Pre-Decisional Enforcement Conference Inspection Report 07201014/2022-201

Agenda

MPC-68M Versions

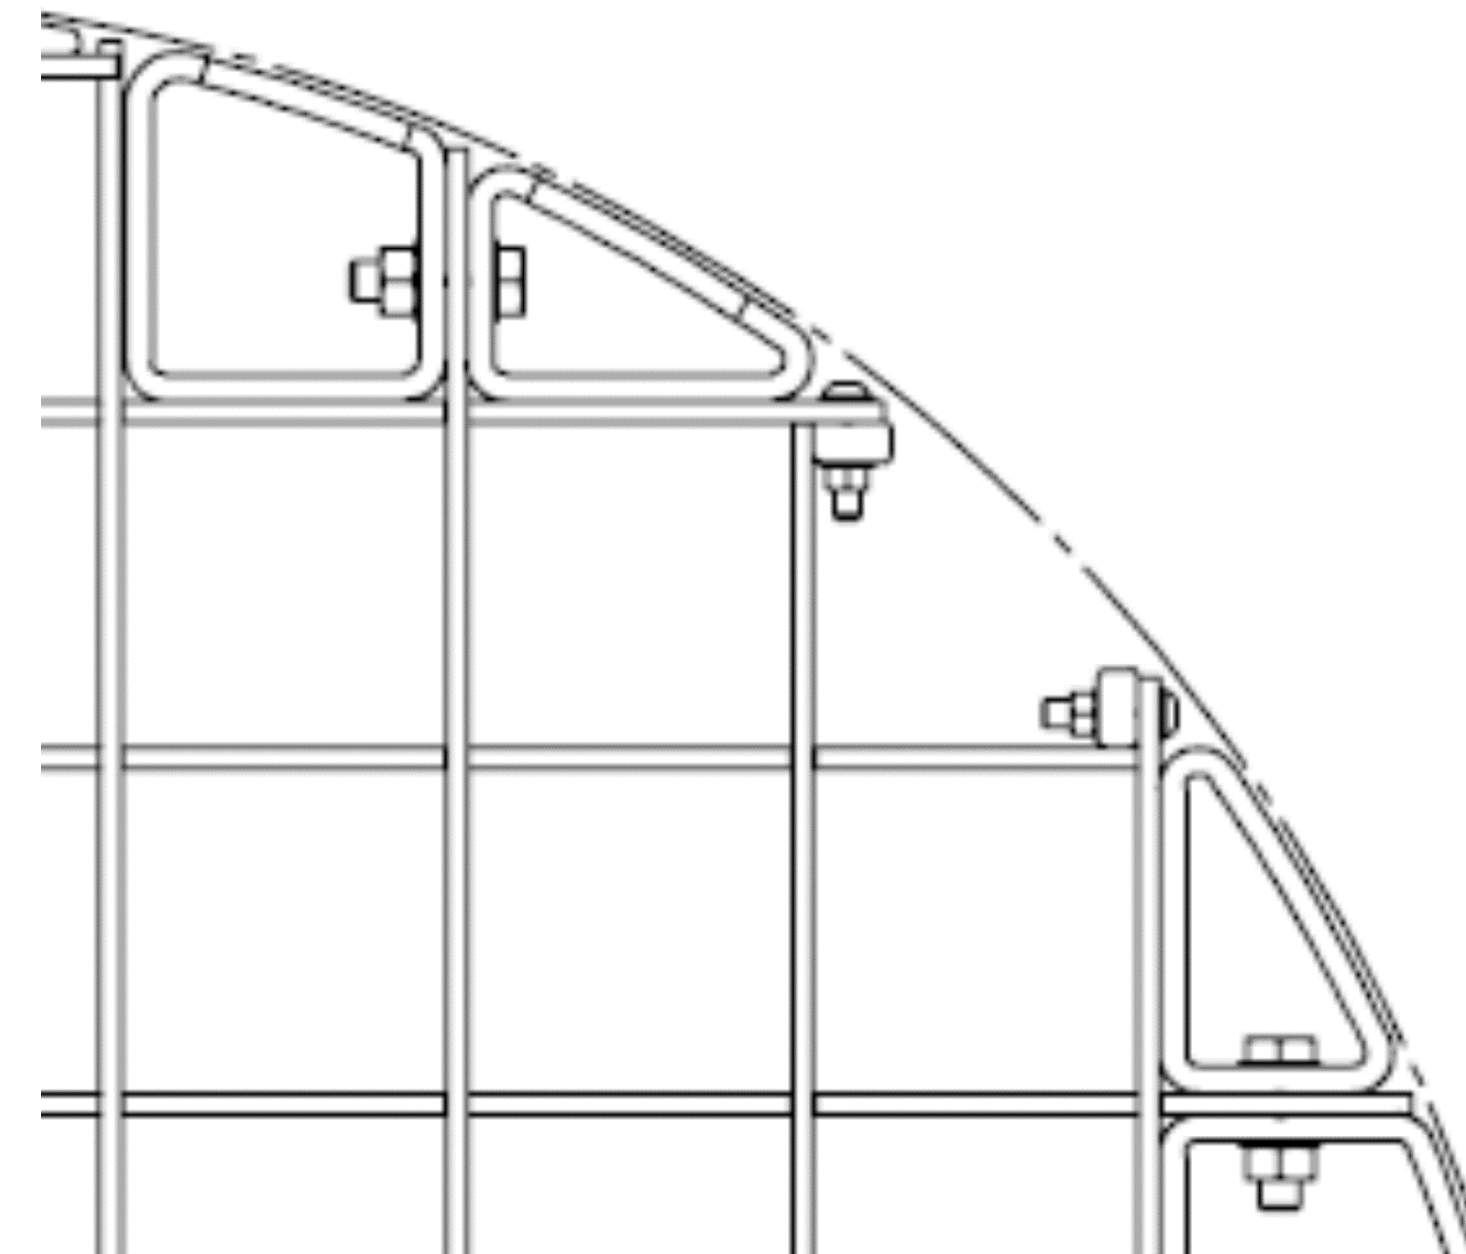
- “1) As described in FSAR revision 22, section 3.III.4.4.3.1(iii), Holtec tied the nodes of the shim to the basket panel at the bolt hole locations to replicate bolted connections at the bolt hole locations the resultant of which changed the way the connections are modeled between the fuel basket and the shims in the FEA model and did not explicitly model the new bolts. Holtec implemented the modification and revised FSAR revision 21, section 3.III.4.4.3.1 (original design) in which the **corner welds between the standard basket and shims** were modeled by bonding the corner elements and assigning them the elastic material properties of the weld, effectively modeling the welds in the FEA. **The team considered this an element change because it was a change to the overall FEA model associated with the tip-over analysis”**

■ Response to Item 1

- ✓ The corner welds described in FSAR Revision 21 are between intersecting Metamic panels within the actual basket structure, there are no welds between “the standard basket and shims”

- ✓ Holtec uses NEI 12-04 as 72.48 program basis, as endorsed by NRC in Reg Guide 3.72
- ✓ NEI 12-04 specifically discusses dimensional changes as input changes which are different than methodology which is “calculational framework” which tend to involve a mathematical expression

- ✓ Holtec modeled the accurate dimensional and physical changes that occurred with the CBS design change and **did not** change the calculational framework of the analysis

- ✓ Previously established understanding of NRC guidance was that a change to the FEA model to accord with geometric changes was not automatically considered a change to the methodology

MPC-68M Versions

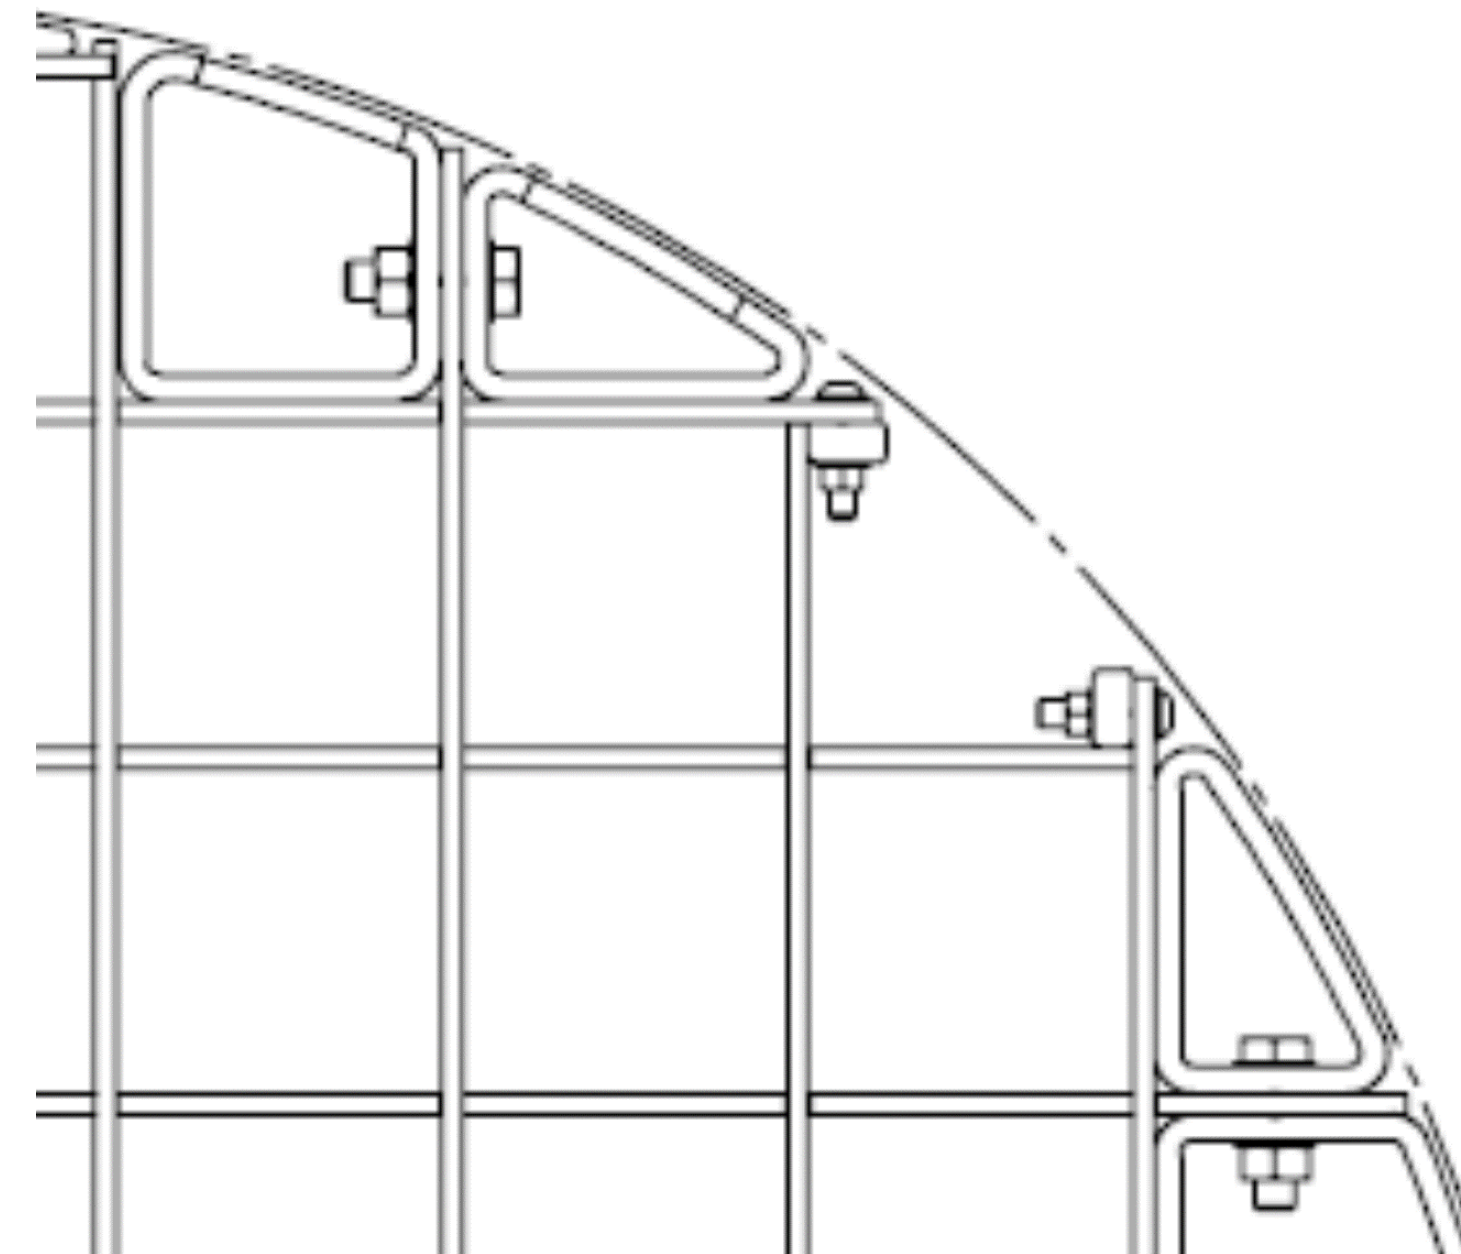
- “2) As described in FSAR revision 22 section 3.III.4.4.3.1(iii), the impact load between the fuel basket and the shims is directly transferred between shims and the horizontal basket panel adjacent to them without inducing shear in the bolts. Additionally, for the modified design, calculation HI-201787-Rev 39, supplement 79, evaluates the bolts for solid shims using an applied 60-g bounding lateral deceleration load from the weight of the basket and fuel assembly, the resultant of which changed the way the strength evaluation was performed for the connections between the fuel basket and the shims. Previously, for the standard basket design, Holtec evaluated **basket welds** using outputs from the FEA to determine the applied moment and shear load as documented in attachment 2 to supplement 65 of Holtec calculation HI-201787-Rev 38. **The team considered this a new or different MOE because Holtec changed the calculational framework on how to evaluate the shims.**”

■ Response to Item 2

- ✓ As in item 1, this is a direct result of the change in geometry of the basket/shim configuration
 - The corner welds described in FSAR Revision 21 are between intersecting Metamic panels within the actual basket structure

- There are no welds between “the standard basket and shims”
- ✓ For the standard (FSW-based) basket design, there is no physical connection between the fuel basket and the shims

- ✓ Evaluation performed for friction stir welds used direct outputs from the ANSYS simulation
 - Friction Stir Welds were an integral part of the standard basket design - not the shims

- ✓ Bolts are a separate physical component
 - A separate analysis was performed as necessary to demonstrate their suitability for the solid shims
- ✓ Not considered a change in methodology - if welds still existed they would have been analyzed using the previously established method

- ✓ Since the CBS basket introduced a different component it was analyzed using a bounding load consistent with the FEA model framework

MPC-32M Variants

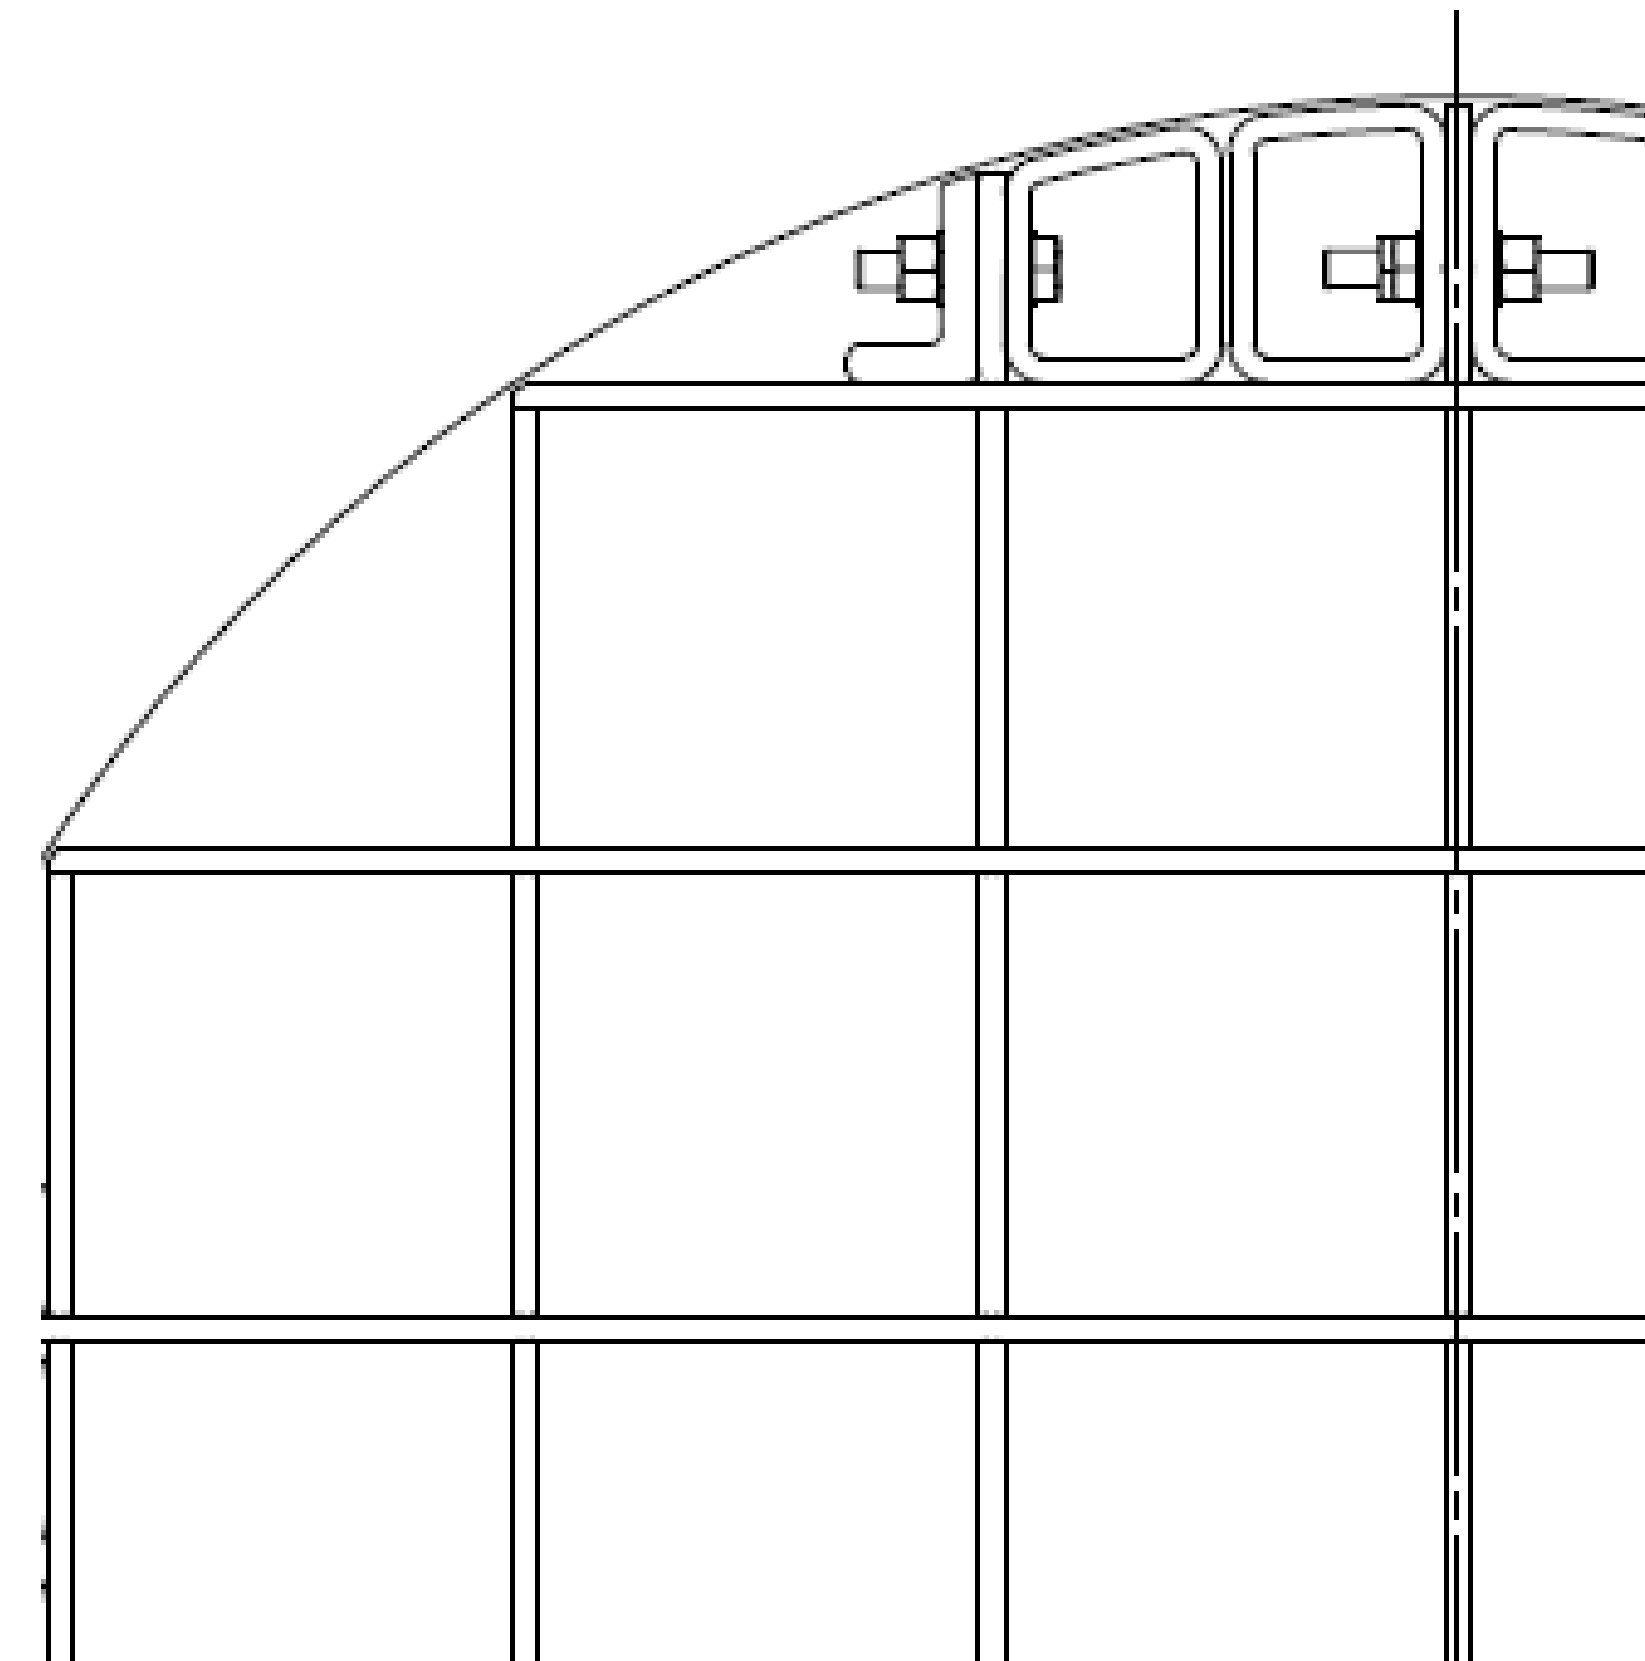
- “6) As described in appendix E.1 of HI-2188448-R3, the impact load between the fuel basket and the shims is directly transferred between the shims and the horizontal basket panel adjacent to them without inducing shear in the bolts. For the standard basket design, Holtec evaluated the welds using an applied 100-g bounding fuel deceleration load in appendix C of HI-218848-R3 (as referenced in HI-STORM FSAR revision 23, section 3.II.4.4.2(ii)). The team considered this a different MOE because **Holtec changed the way the strength evaluation was performed for the connections between the fuel basket and the shims by using a different assumption, which was inconsistent with the previous licensing basis assumptions.** (similar to AV A.2)

■ Response to Item 6

- ✔ Similar to item 2, this is a direct result of the change in the basket/shim geometry
 - The corner welds described in the FSAR are between intersecting Metamic panels within the actual basket structure, there are no welds between “the standard basket and shims”

- ✔ For the standard basket design, there is no physical connection between the fuel basket and the shims, and therefore there is no FSAR method for evaluating basket-to-shim connections

- ✔ The evaluation performed for the Friction Stir Welds used direct outputs from the ANSYS simulation because those were an integral part of the standard basket (not the shims)

- ✔ This was not a change in methodology - if basket welds still existed they would have been analyzed the using previously established method
- ✔ Since the CBS basket variant introduced a different component (bolted shims), the bolts were analyzed using a bounding load consistent with the FEA model framework
